2.0 SITE CHARACTERISTICS

The applicant addressed the PSEG Site location and description in Site Safety Analysis Report (SSAR) Section 2.1.1, "Site Location and Description" of the Early Site Permit (ESP) application, in which the applicant provided site-specific information related to site location and description, including political subdivisions, natural and manmade features, population, highways, railways, waterways, and other significant features of the area. In SSAR Figure 1.2-1, "PSEG Site Location—6-Mile Radius," and SSAR Figure 1.2-2, "PSEG Site Location—50-Mile Radius," the applicant showed the PSEG Site location and the surrounding area within 9.6 kilometers (km) (6 miles (mi)) and 80 km (50 mi), respectively, and identified the prominent natural and manmade features, including the Delaware River, towns, and major transportation routes.

Figure 2.3-4 ASCE/SEI 7-05, Figure 6-1, "Basic Wind Speed"

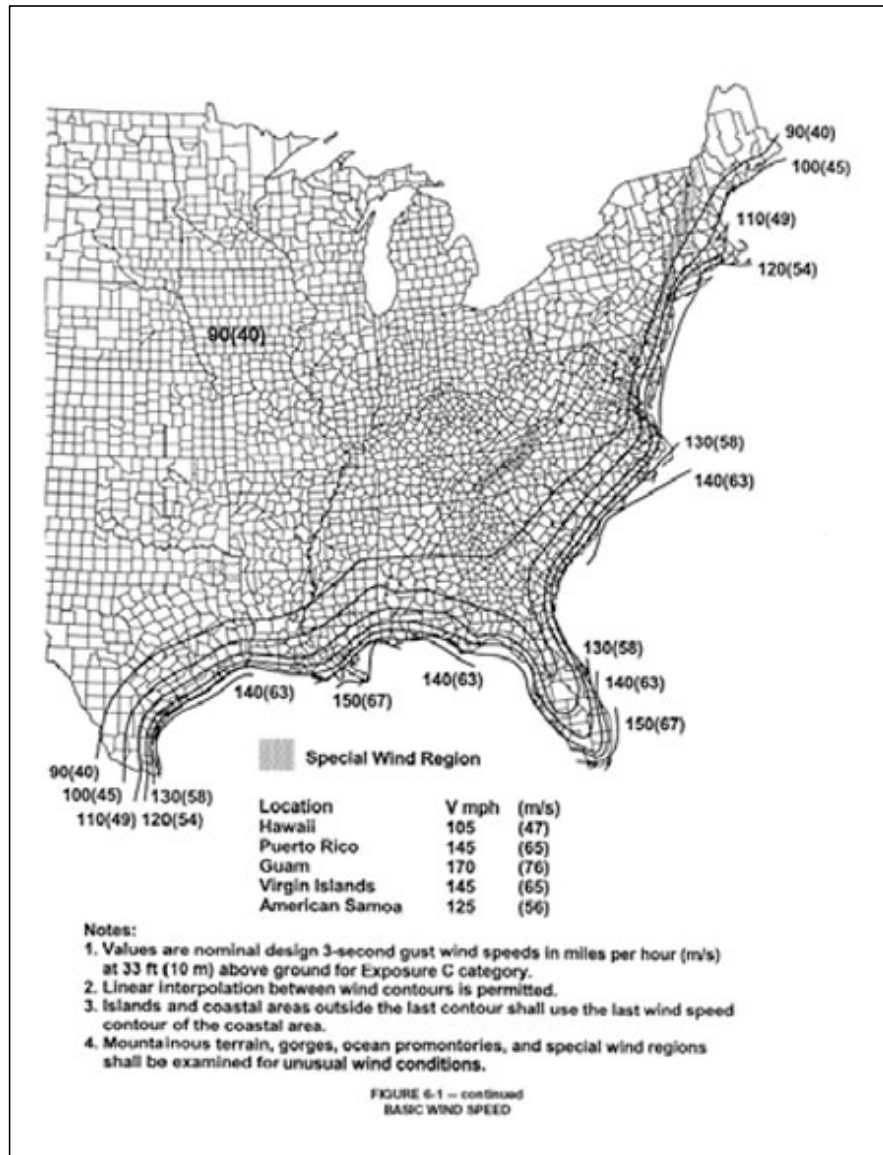
Using a plot of basic wind speeds presented in ASCE/SEI 7-05 (reproduced in Figure 2.3-4 of this report) for the portion of the United States (U.S.) that includes the proposed PSEG Site, the applicant determined a 50-year return period wind speed of 40.2 m/s (90 mph). The applicant also used data from the AFCCC Engineering Weather Data (EWD) compact disc (CD) (Air Force Combat Climatology Center (AFCCC), National Climatic Data Center (NCDC), "Engineering Weather Data, 2000 Interactive Edition," developed by the AFCCC and published in the NCDC, Ashville, NC, 1999). The applicant noted that the highest 50-year recurrent wind speed at any of the first order reporting stations in the site area is 49 m/s (110 mph), as reported at Philadelphia International Airport. The staff confirmed this value using the EWD. This value is associated with a mean recurrence interval of 50 years². Using a conversion factor listed in ASCE/SEI 7-05, the applicant derived a 100-year return period 3-second gust wind speed site characteristic value of 52.6 m/s (117.7 mph), as presented in SSAR Table 2.0-1.

² The staff noted that the 50-year recurrence, 3-second gust basic wind speed reported by the EWD is based on data from ASCE 7-95. The 50-year recurrence basic wind speeds were updated 3 years later in ASCE 7-98 and were subsequently lowered to the basic wind speeds found in ASCE 7-05. The basic wind speeds presented in ASCE 7-05 were updated "based on a new and more complete analysis of hurricane wind speeds." A complete discussion of the reasons for this change can be found in ASCE/SEI 7-05, Section C6.5.4, "Basic Wind Speed."

Figure 2.3-5 ASCE 7-05, "Figure 7-1: Ground Snow Loads, p_g , for the United States (lb/ft²)"

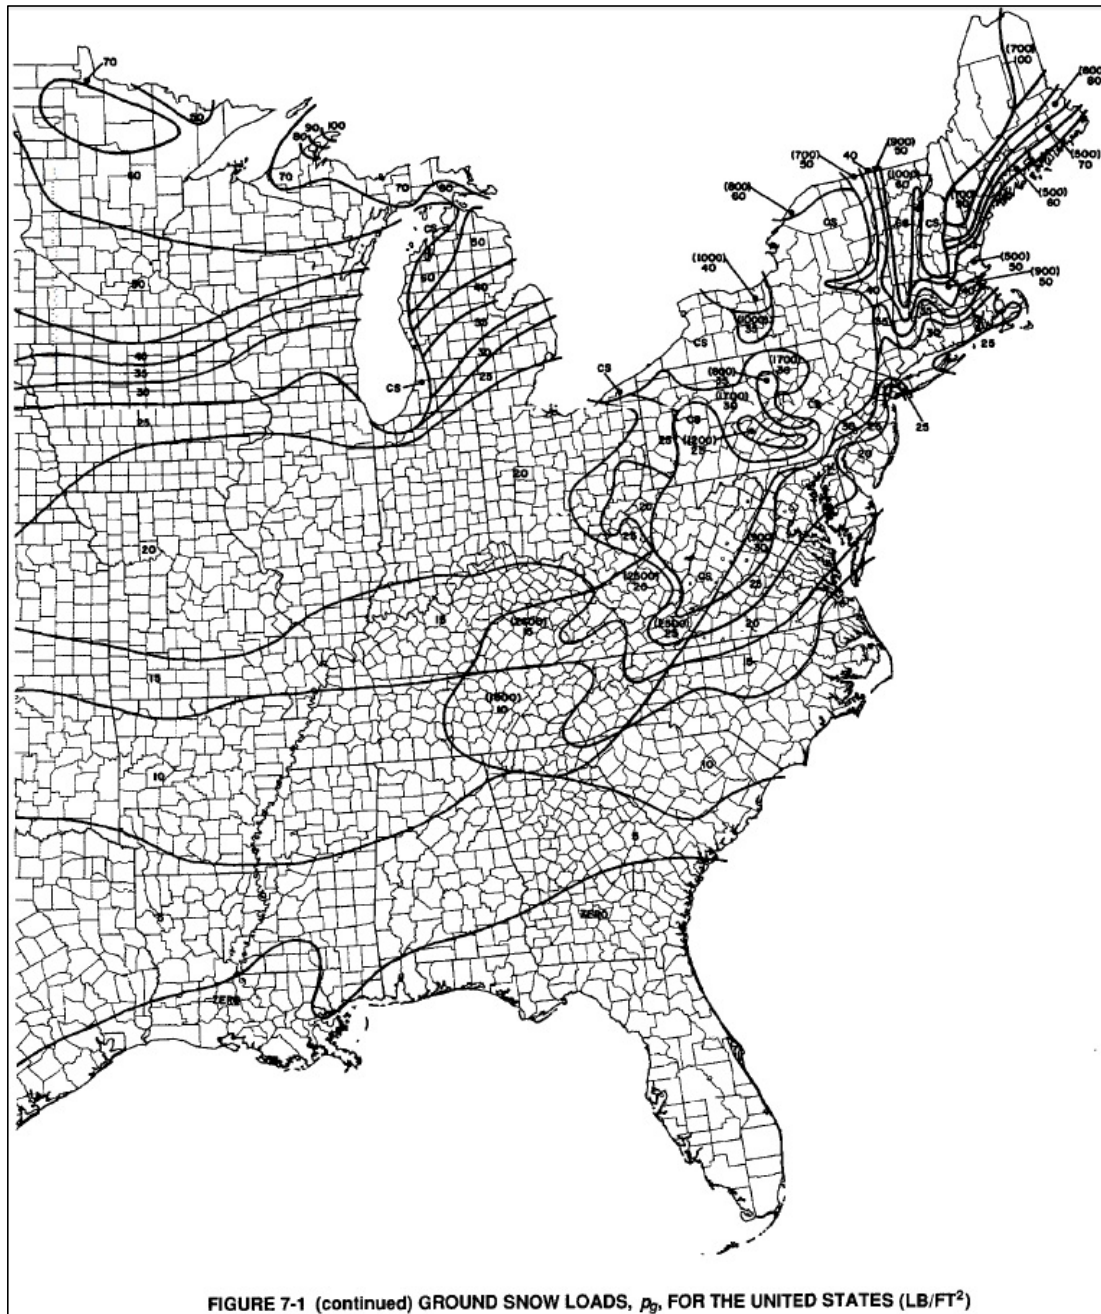
period ground-level snowpack, as given in ASCE/SEI 7-05, Figure 7-1, “Ground Snow Loads, p_g for the United States (lb/ft²),” (reproduced in Figure 2.3-5 of this report) is equal to 117.2 kg/m² (24 lb/ft²) when converted to a 100-year weight. The applicant also presented its extreme liquid winter precipitation event as 533 mm (21.0 in.) liquid depth, which was identified as the 48-hour PMWP. Using ASCE/SEI 7-05 and NCDC Snow Climatology⁴ the staff independently confirmed the winter precipitation data presented by the applicant and finds it complete and acceptable.

Figure 2.4.6-1 Major faults in the Greater Antilles region

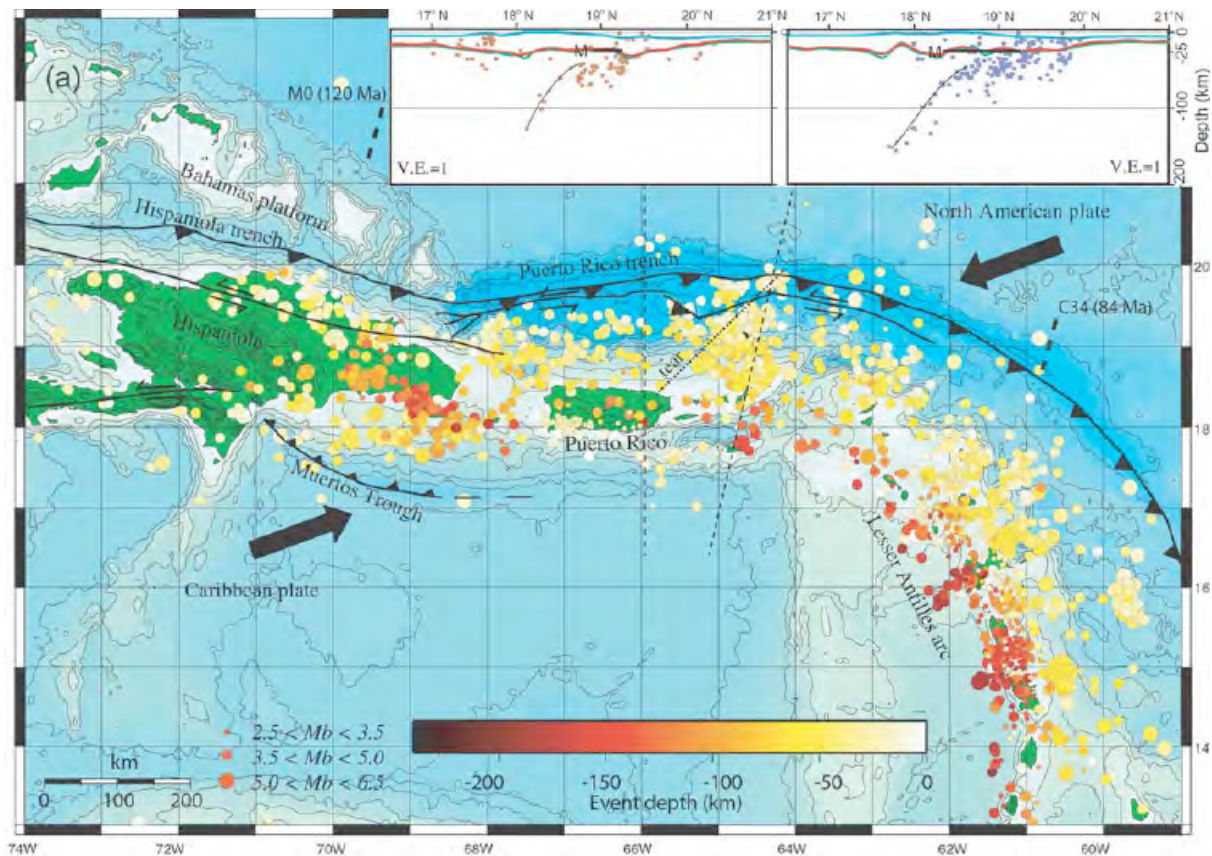
In RAI 20, Question 02.04.06-2, the staff requested that the applicant provide an updated figure showing a maximum slope angle of 0.3 degrees and an updated figure/reference to related work in SSAR Section 2.5.5 in a revision of the SSAR. In a May 11, 2011, response to RAI 20, Question 02.04.06-2, the applicant stated that SSAR Figure 2.4.6-1 has a scale of slope (i.e., dimensionless rise over run) ranging from 0 to 0.002. At the maximum scale value, the angle of the slope would equal 0.115 degrees. To minimize any further confusion over this figure, the applicant revised the figure to have a dimensioned scale in angular degrees. The staff verified that Revision 1 of the ESP application (May 21, 2012) contains the applicant's committed change.

Figure 2.4.6-1 shows the naturally occurring angular topography slopes on a grid in the vicinity of the PSEG Site, and shows a maximum slope value of 0.3° occurring inland of the site. Stability analysis will be conducted during the COLA phase of the project, and will include consideration of failure surfaces that extend into the Delaware River adjacent to the site as discussed in SSAR Subsection 2.5.5.1.

SSAR Figure 2.4.6-1, provided in Enclosure 3 of the applicant's May 11, 2011, response to RAI 20, Question 02.04.06-2, was revised by the applicant and submitted in a May 31, 2011, supplement to the May 11, 2011, response. The applicant committed to revise the SSAR to provide a scale in angular degrees. The staff confirmed that Revision 1 of the ESP application (May 21, 2012) contains the applicant's committed changes. Accordingly, the staff considers RAI 20, Question 02.04.06-2 resolved.

Figure 2.4.14-1 Proposed PSEG Site Layout (based on SSAR Revision 3, Figure 1.2-3)

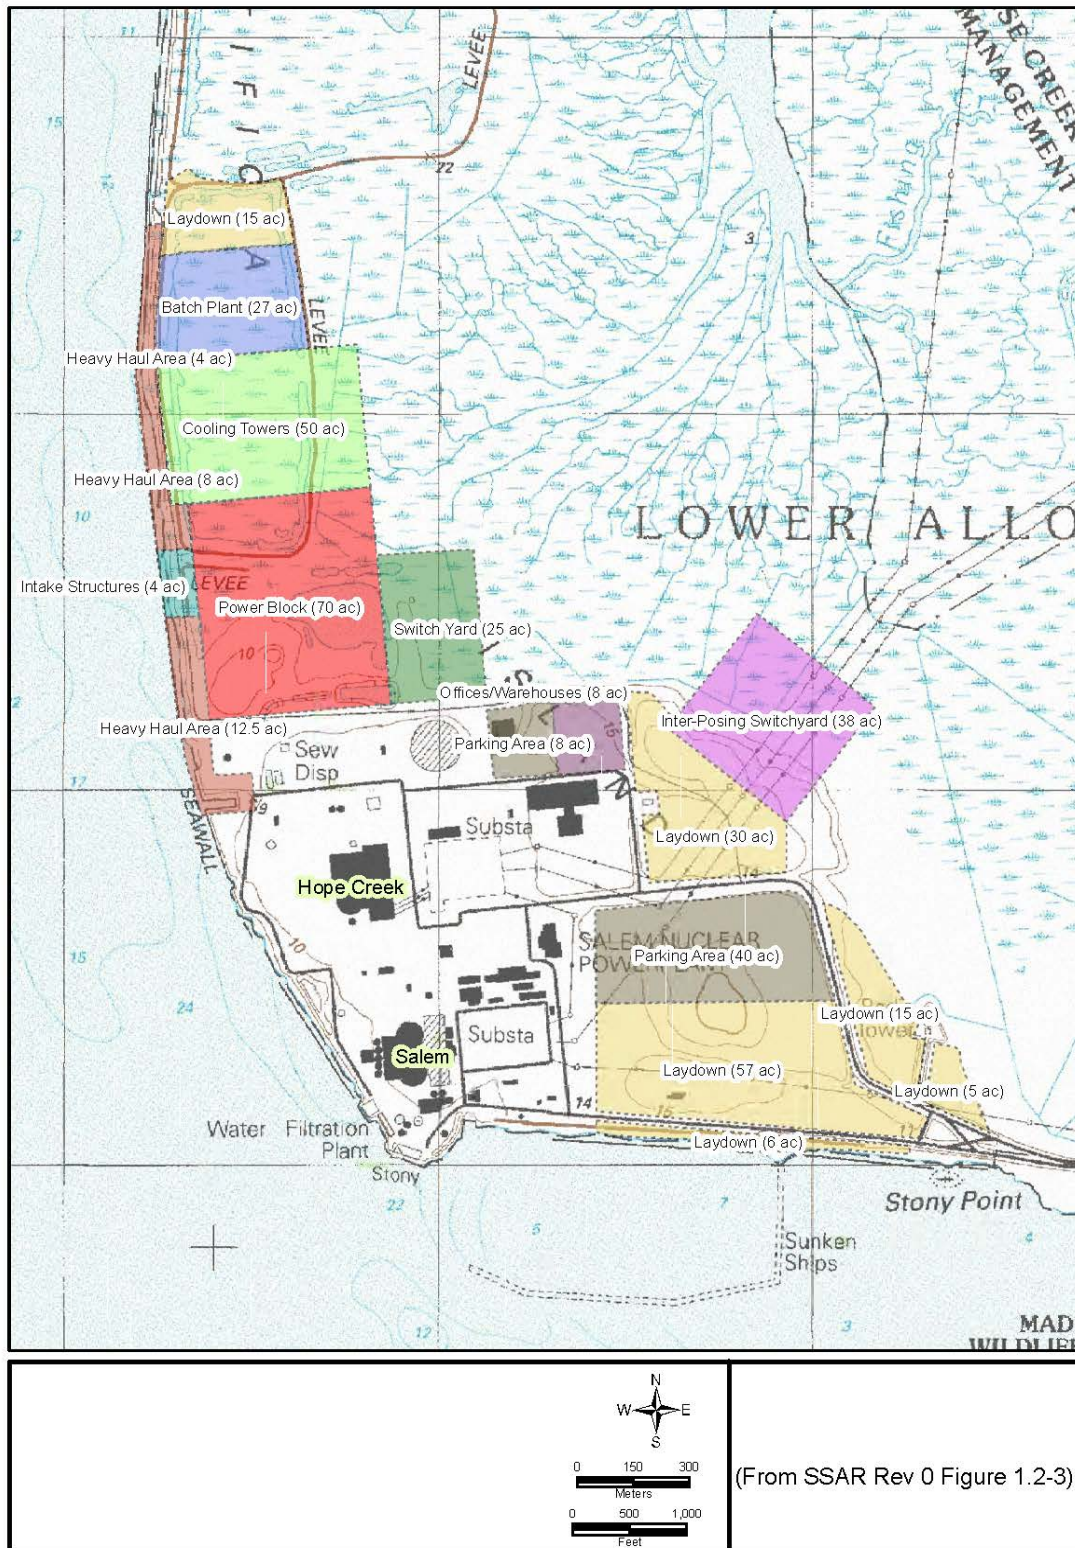
Coordinates for the power block reference point are provided in geodetic and UTM systems. SSAR Section 2.1.1.2 (Paragraph 2) and SSAR Figure 1.2–3 identified the UTM coordinates without units, which appear to be measured in feet. Therefore, in RAI 9, Question 02.01.01-1, the staff requested that the applicant annotate the list of UTM coordinates in the SSAR and to do so in the marginal notes on SSAR Figure 1.2-3 with the correct units of measure. In a March 21, 2011, response to RAI 9, Question 02.01.01-1, the applicant provided a revision to

The PSEG proposed Exclusion Area Boundary (EAB) is a circle at least 600 m (1968 ft) from the edge of the power block area in all directions as shown in SSAR Figure 1.2-3. As shown in SSAR Figure 2.1-23, the proposed EAB extends beyond the PSEG Site property line to west (into the Delaware River) and to the north and northeast. The total area that the EAB encompasses is 3.0 km² (743 acres), of which 0.91 km² (224 acres) is in the Delaware River and 1.17 km² (288 acres) is in land that PSEG currently owns. PSEG will own an additional 0.344 km² (85 acres) of land when it completes property acquisition with the USACE. The land within the EAB that PSEG does not own consists of 0.59 km² (146 acres), which the Federal Government owns. No public roads, railroads, or structures other than the existing PSEG power plant facilities are located within any part of the EAB. From the information in SSAR Section 2.1.1.2 and SSAR Figure 1.2-3, it appears to the staff that the additional 0.344 km² (85 acres) of land is bounded by the area, as described in "PSEG Proposed New Property Line." In RAI 9, Question 02.01.01-2, the staff requested that the applicant distinguish the different areas in EAB and clarify them in SSAR Section 2.1.1.2 and SSAR Figure 1.2-3 accordingly. In a March 21, 2011, response to RAI 9, Question 02.01.01-2, the applicant provided clarification along with proposed revisions to SSAR Section 2.1.1.2 and SSAR Figure 1.2-3. The staff reviewed the response and found the applicant's clarification appropriate and adequate, and therefore acceptable. The staff also confirmed the inclusion of the proposed revisions in SSAR Section 2.1.1.2 and SSAR Figure 1.2-3, Revision 1, submitted on May 21, 2012. Accordingly, the staff considers RAI 9, Question 02.01.01-2, resolved.

The land boundary, on which technical specification limits for release of gaseous radioactive effluents are based, is the PSEG Site property line shown in SSAR Figure 1.2-3. The minimum distance from the center point to the property line is 265.8 m (872 ft) in the west direction. The staff notes this suggests that it is one of the site boundary receptor locations being considered for dose evaluation. However, in a September 9, 2011, response to RAI 35, Question 02.03.05-04 (on SSAR Section 2.3.5, "Long-Term Atmospheric Dispersion Estimates for Routine Releases"), the applicant stated that although X/Q and D/Q values have been calculated for all 16 radial directions at the PSEG Site boundary including the PSEG Site boundary location receptor addressed above at 265.8 m (872 ft) in the west direction, sectors adjacent to the Delaware River (sectors SE to NW in clockwise direction) are not considered in the dose evaluations. Therefore, in follow up RAI 49, Question 02.01.01-3, the staff requested that the applicant update the information in SSAR Section 2.1.1.3 for clarity and consistency. In a February 24, 2012, response, the applicant provided information clarifying and justifying

SSAR text in Section 2.1.1.2 and SSAR Figure 1.2-3 with the English unit of measurement (in feet), and committed to revise the SSAR with this information. The staff reviewed the applicant's response and subsequently confirmed that SSAR Revision 1, submitted on May 21, 2012, contained the information as committed in the RAI response. Accordingly, the staff finds the applicant's response acceptable and considers RAI 9, Question 02.01.01-1, resolved.

why sectors adjacent to the Delaware River are not considered in the dose evaluations. The applicant also committed to revise SSAR Section 2.1.1.3 with this information. The applicant specifically stated in the February 24, 2012, response to RAI 49, Question 02.01.01-3, that the X/Q and D/Q values (SSAR Table 2.3-37) at the PSEG Site boundary, adjacent to the Delaware River (sectors SE to NW in clockwise direction), are not considered in the associated analyses for radiological exposure from routine gaseous effluents, and that excluding the area adjacent to the Delaware River is acceptable because of the negligible time any individual is expected to spend in this area during any one-year period. The applicant further stated that the X/Q and D/Q values considered in the associated analyses for radiological exposure due to the routine gaseous effluents are those in sectors NNW to ESE (clockwise direction). The staff reviewed the applicant's response, clarification, and conclusion that doses resulting from radiological exposure will be negligible based on short-term presence of individuals in this area during any one-year period. The staff finds the applicant's clarification appropriate and adequate, and therefore acceptable. The staff also confirmed the inclusion of the proposed revision in SSAR Section 2.1.1.3, Revision 1, submitted on May 21, 2012. Accordingly, the staff considers RAI 49, Question 02.01.01-3, resolved.
